PLANNING BOARD MEETING AGENDA

RE: 71 Sullivan Street – Stormwater Review

DATE: August 28, 2019

COMMUNITY PARKING LOT 71 SULLIVAN STREET BERWICK, MAINE

Figure 1: Potential Underdrain Layout

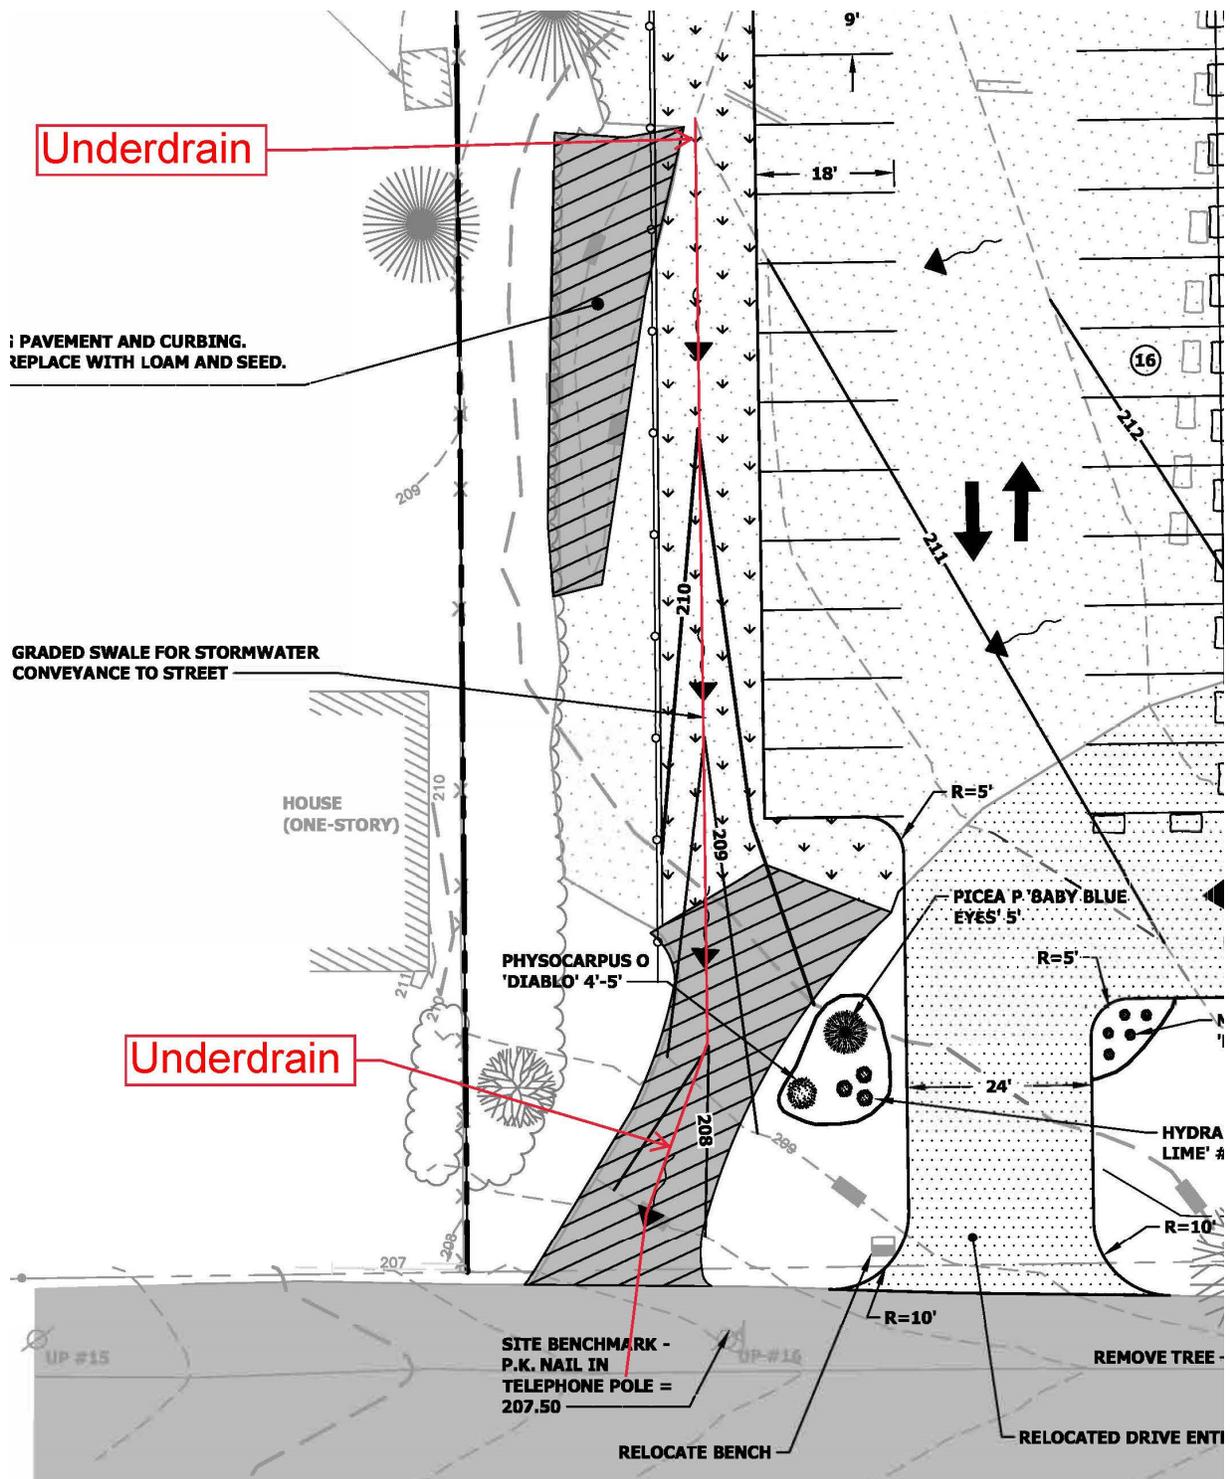
MMI understands the southerly abutter is concerned about possible additional stormwater runoff from the project heading towards their property and the potential for groundwater issues to their existing house. The proposed conditions generally match existing conditions topography, with a shallow drainage swale intercepting stormwater runoff from the parking lot and redirecting the flow towards the street, which will enter into the existing paved swales to the municipal stormwater collection system. By removing impervious coverage and re-establishing lawn areas, it is presumed that the post-development stormwater runoff will be less than the pre-development conditions.

To address potential stormwater runoff infiltrating into the soils and groundwater, MMI recommends carrying the parking lot drainage swale back further to the 211' elevation contour (show spot grades, if necessary) and install a perforated underdrain beneath the swale to potentially intercept surface runoff and groundwater heading towards the southerly abutters property. The new underdrain could either daylight at the 208' contour and discharge into the existing roadside swale or tie in directly to the municipal stormwater system within Sullivan Street. Please refer to Figure 1 for a potential configuration.
